Dendrobium Area 3C – Longwall 21A – SMP Variation

However, in order to avoid an intrusive sill that was found at the approved commencing end of Longwall 21A, a revised longwall start position 28 m to the east of the approved start position has been developed. As such, Illawarra Coal Holdings Pty Ltd (ICHPL) request that the Department approve a variation to the Longwall 21A SMP Approval to account for this small change.

The effects of the proposed modified commencing end of Longwall 21A
on previous subsidence predictions and impact assessments

Predicted profiles of incremental vertical subsidence, tilt along and tilt across the 330 kV transmission line due to mining of LW21A only

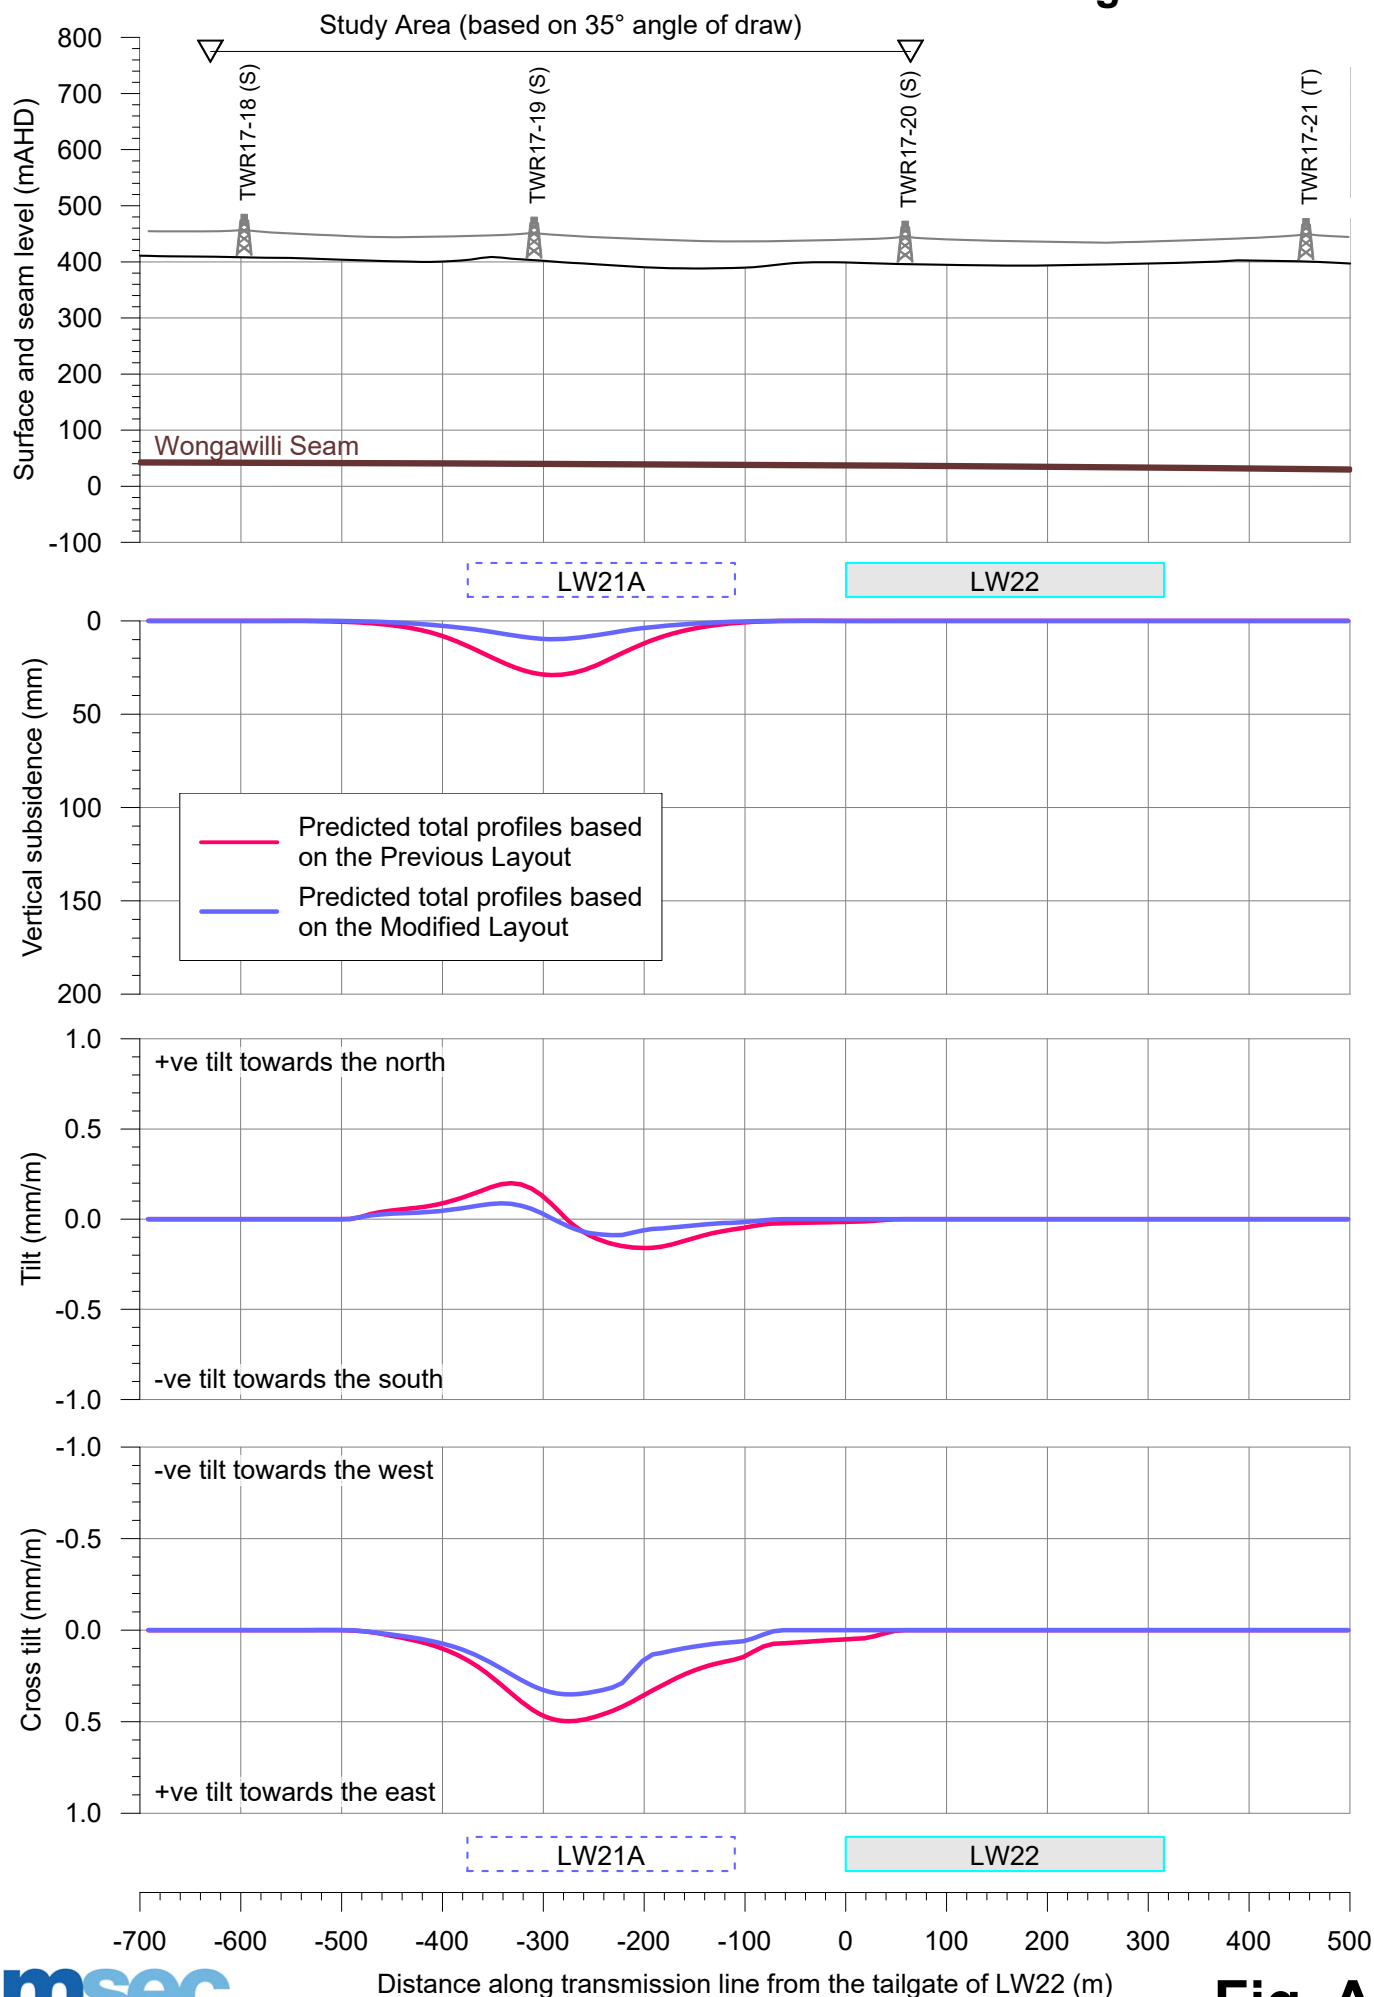
Tower TWR17-19 is also located west of the future LW21A at a distance of 65 m based on the Previous Layout and 95 m based on the Modified Layout. That is, the distance of this tower from LW21A increases by approximately 30 m due to the proposed modification.

The predicted profiles of incremental vertical subsidence, tilt along and tilt across the 330 kV powerline due to the mining of LW21A only are illustrated in Fig. A.04 in Appendix A. The profiles based on the Previous Layout and Modified Layout are shown by the red lines and blue lines, respectively, in this figure.

DRAWING No:
MSEC1527-08

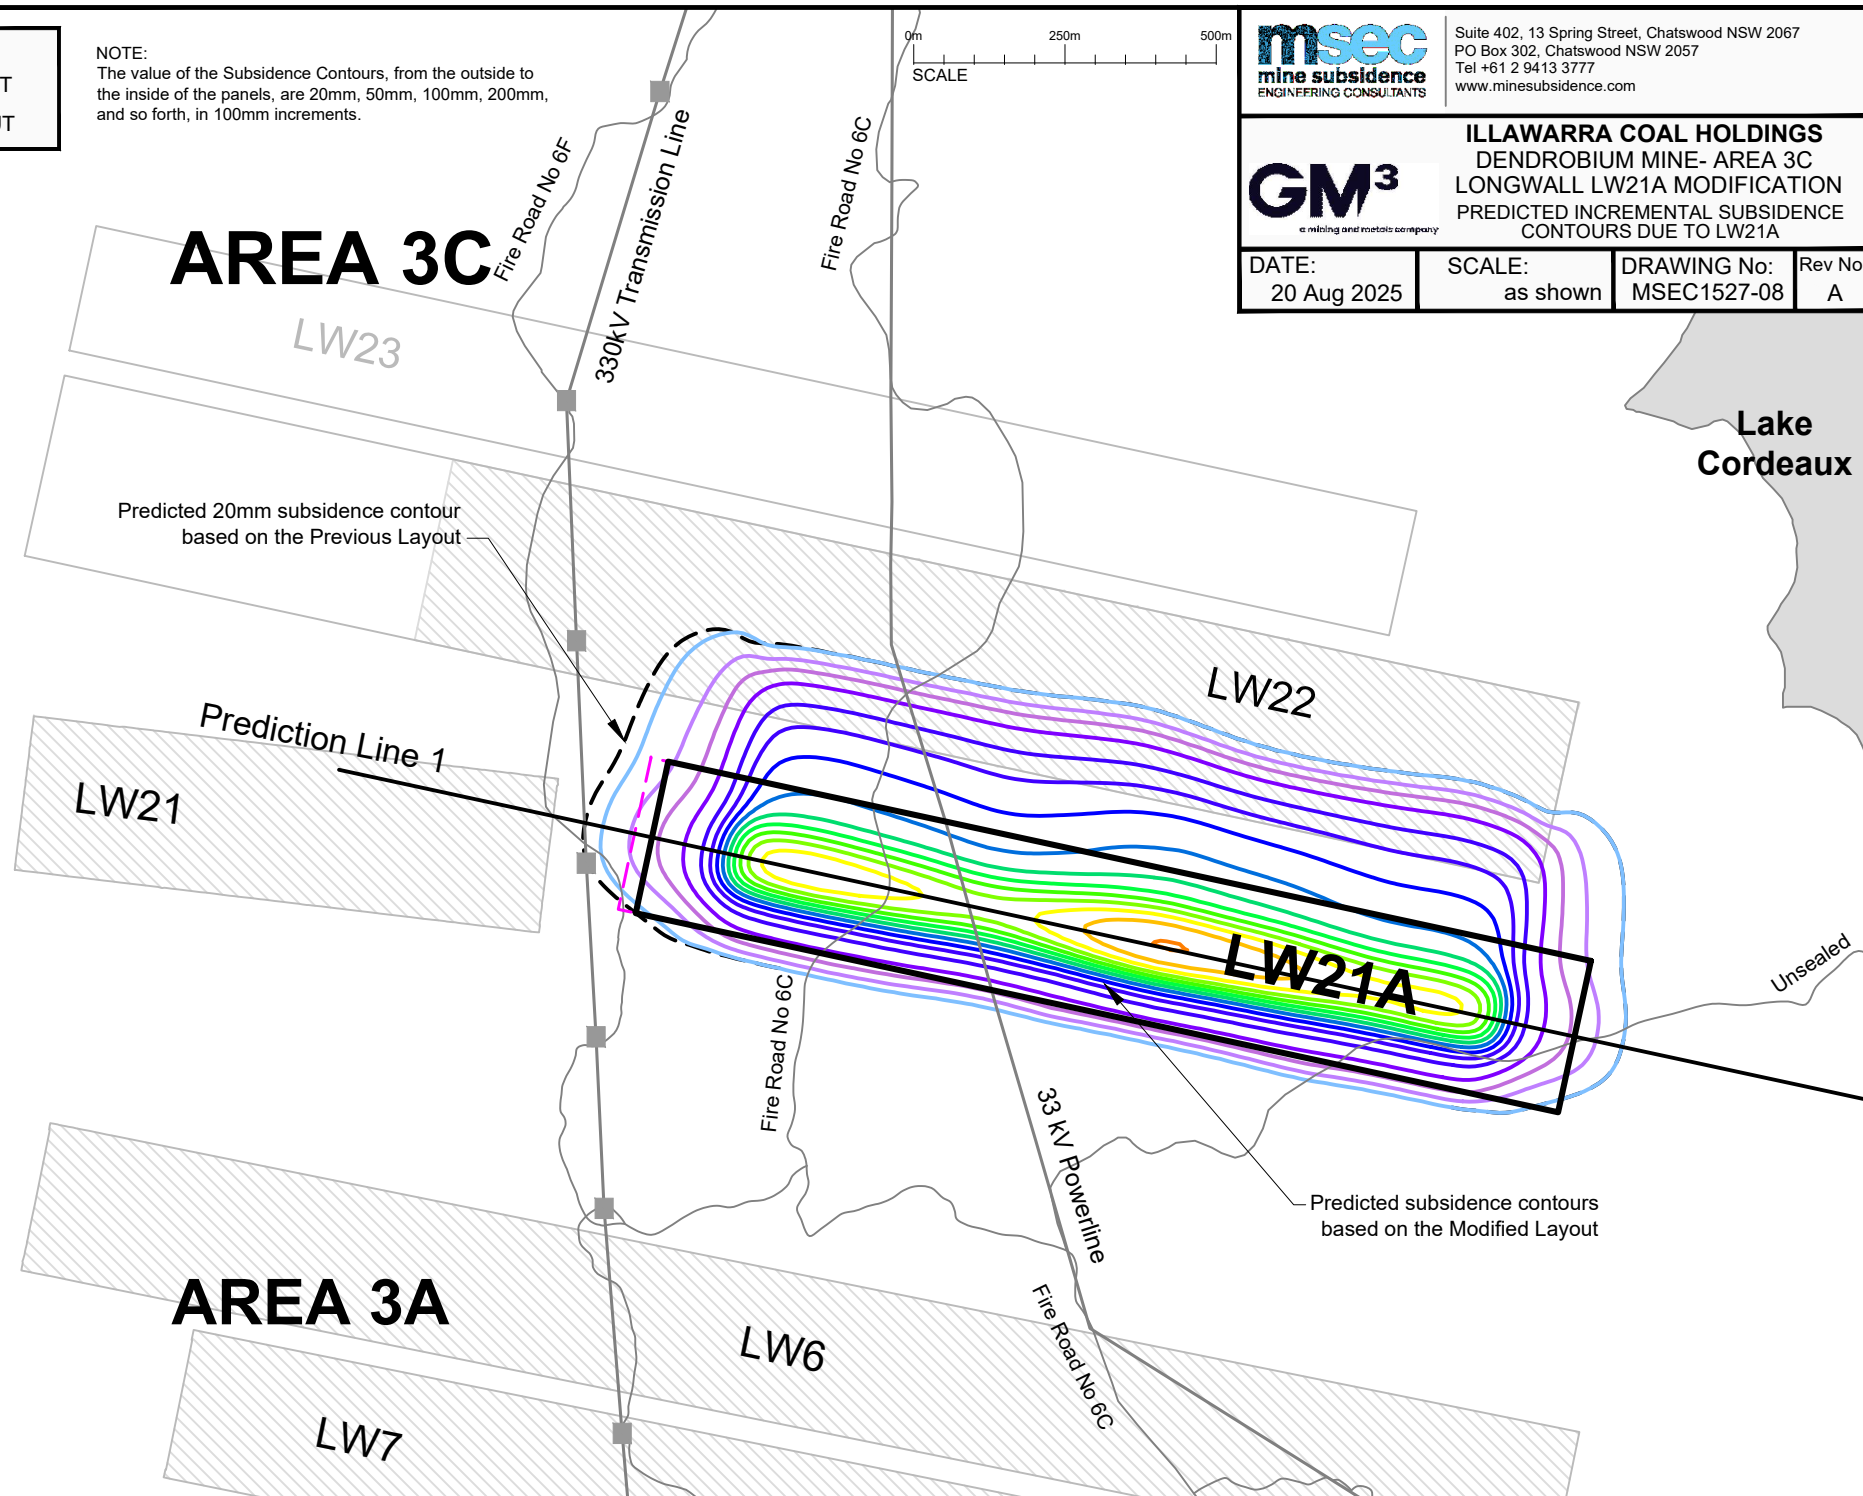
The predicted incremental subsidence contours due to the mining of LW21A, based on the Modified Layout, are shown in Drawing No. MSEC1527-08 in Appendix B. The predicted incremental 20 mm subsidence contour, based on the Previous Layout, is also shown in this drawing for comparison.

The extent of vertical subsidence decreases due to the proposed shortened commencing (i.e. western) end of LW21A. The surface area located within the predicted incremental 20 mm subsidence contour for this longwall is 87 hectares (ha) based on the Previous Layout reducing to 86 ha based on the Modified Layout.

DRAWING No:
MSEC1527-09

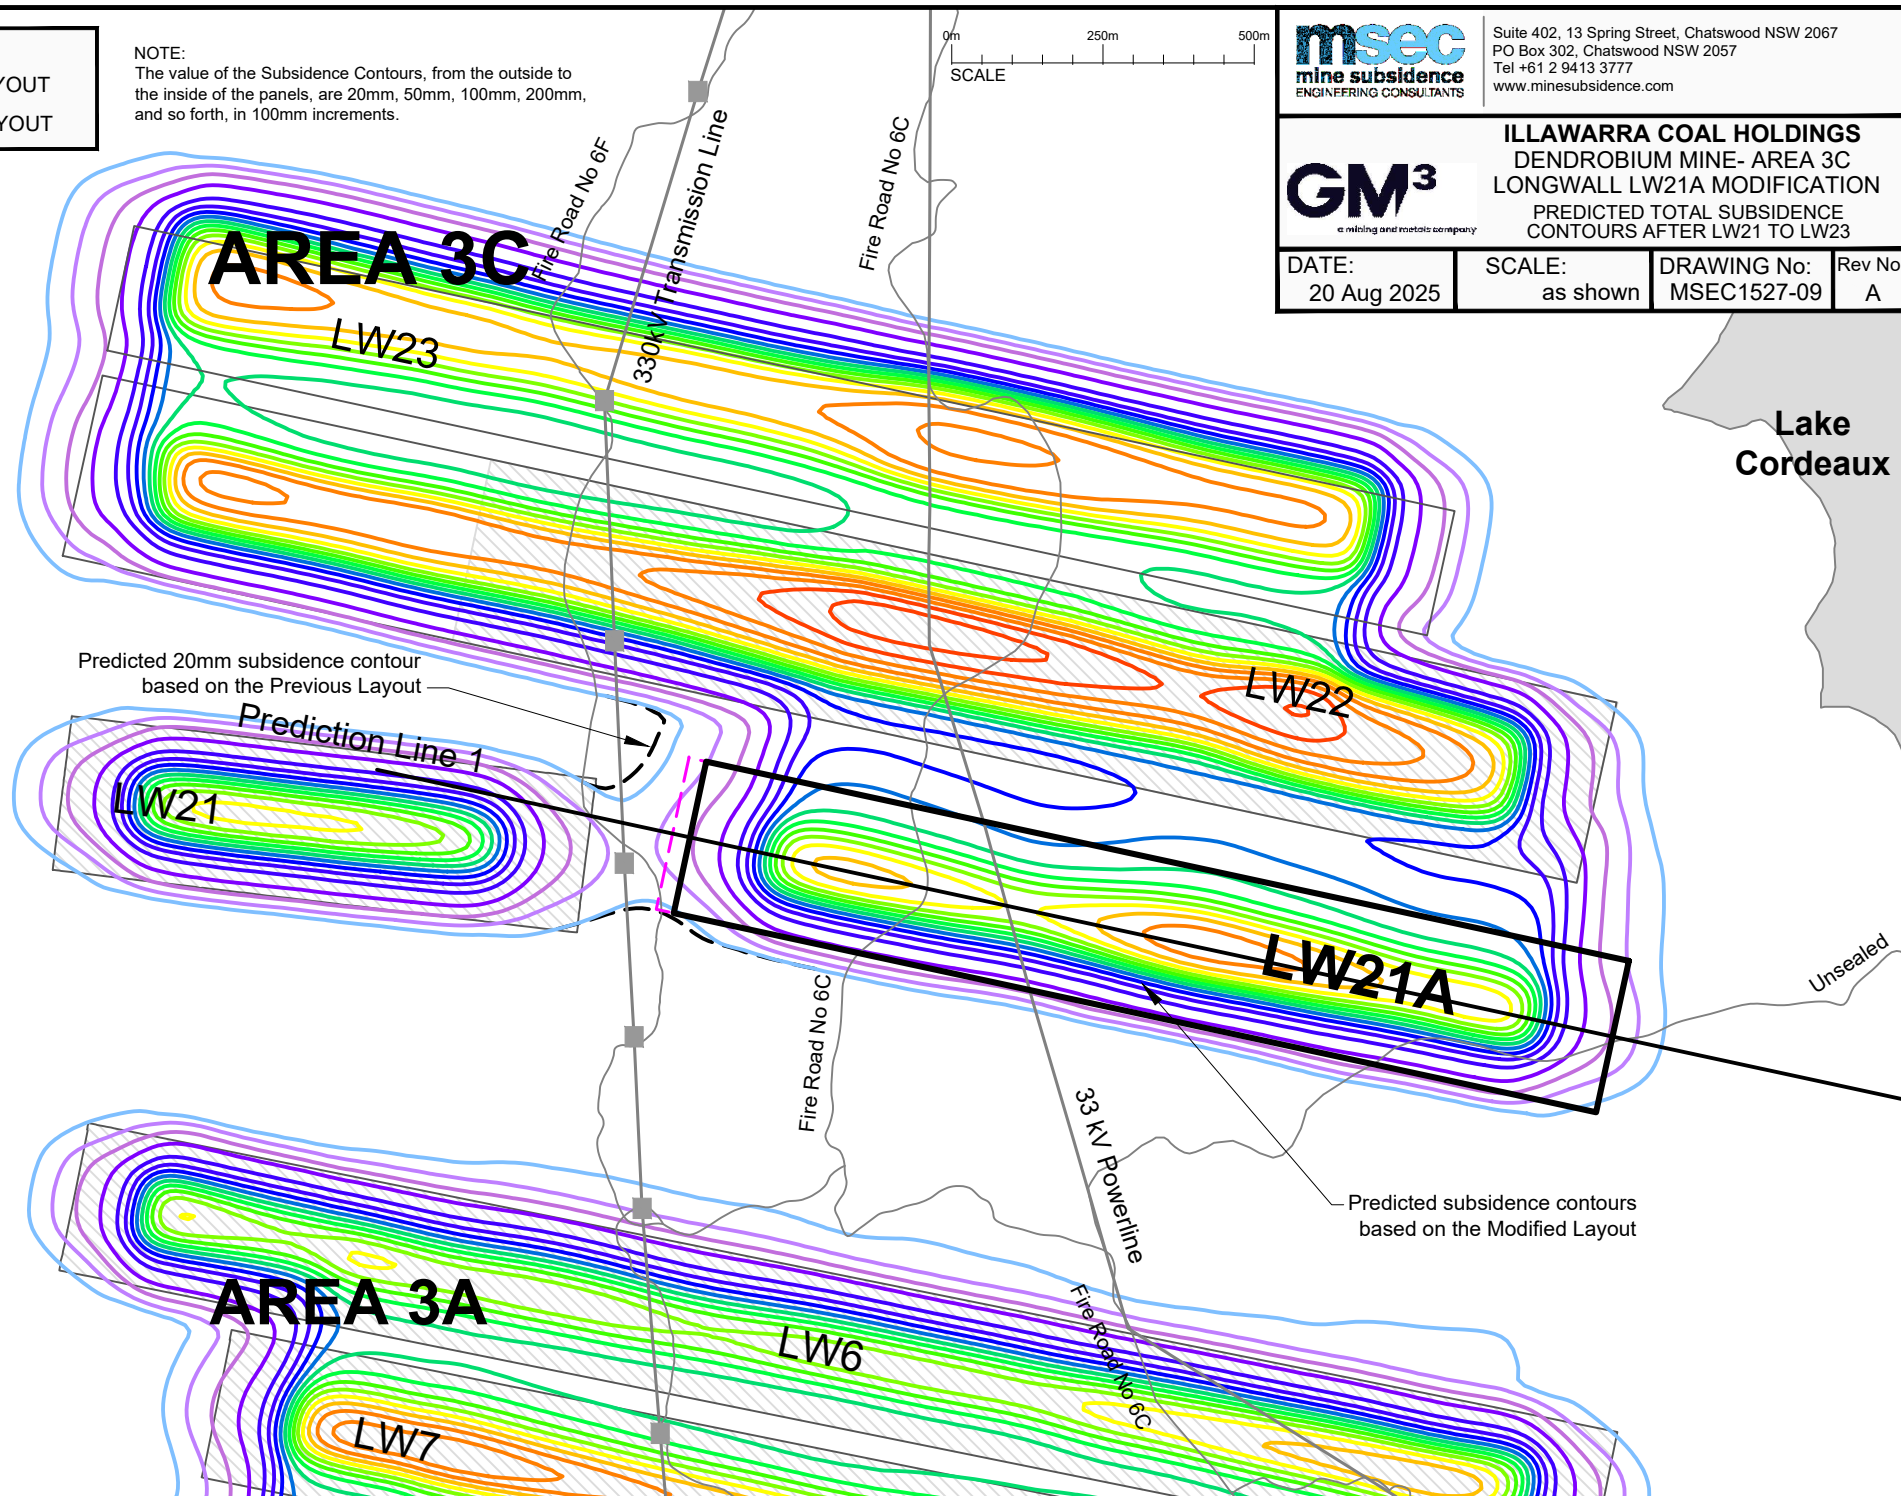
The predicted total subsidence contours due to the mining of LW21, LW22, LW21A and LW23, based on the Modified Layout, are shown in Drawing No. MSEC1527-09 in Appendix B. The predicted total 20 mm subsidence contour, based on the Previous Layout, is also shown in this drawing for comparison.

Dendrobium and Longwall 21A mine plan including proposed variation **Figure 1-1**

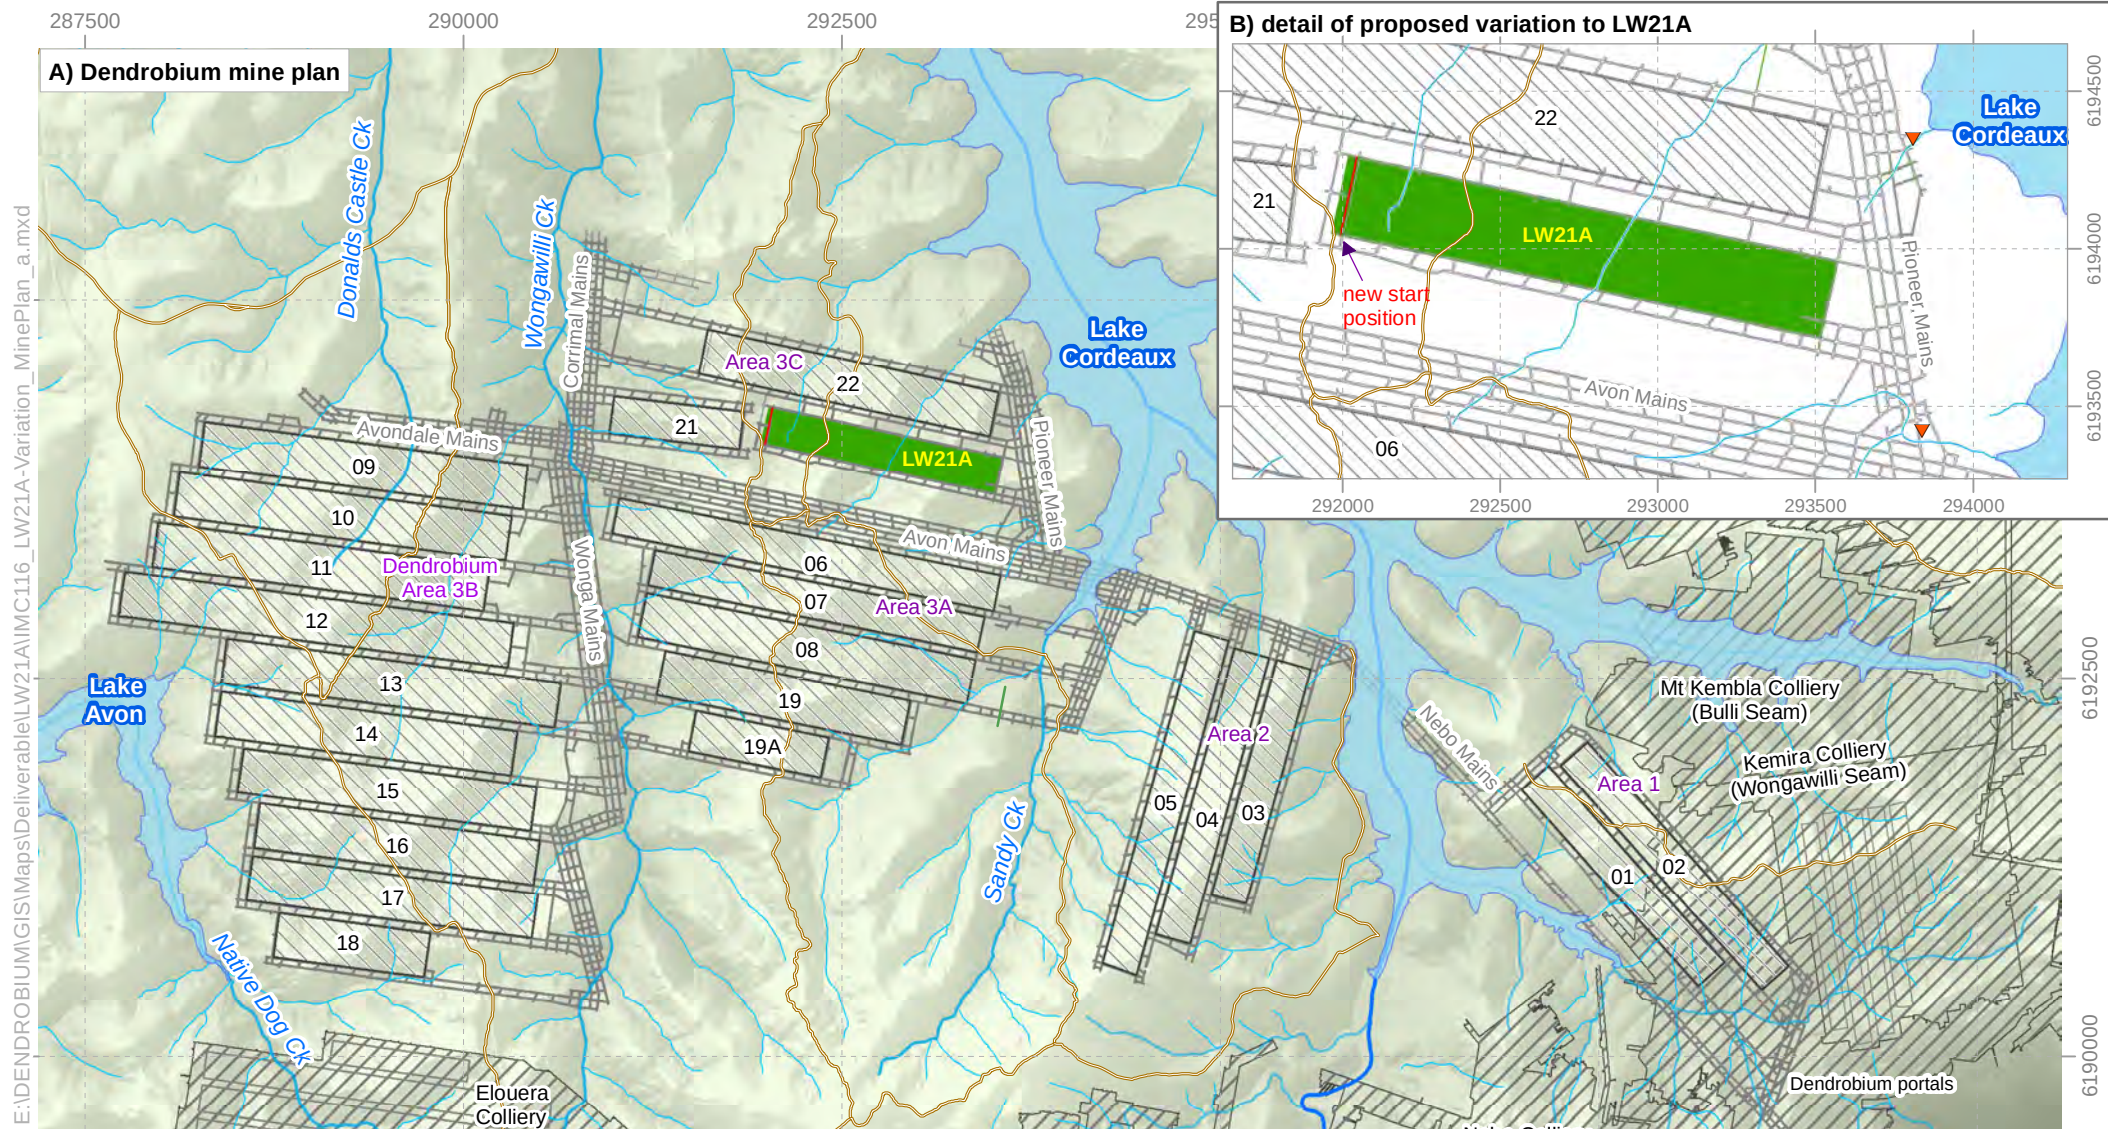
Given the small change (moving the starting position 28 m in-by, or reducing it by <2% of the total length), this memo documents the likely changes based on the conceptualisation. Running the numerical model to make updated forecasts of effects is not warranted, and for such a small change, the model results of the approved and varied mine plan are likely indistinguishable.
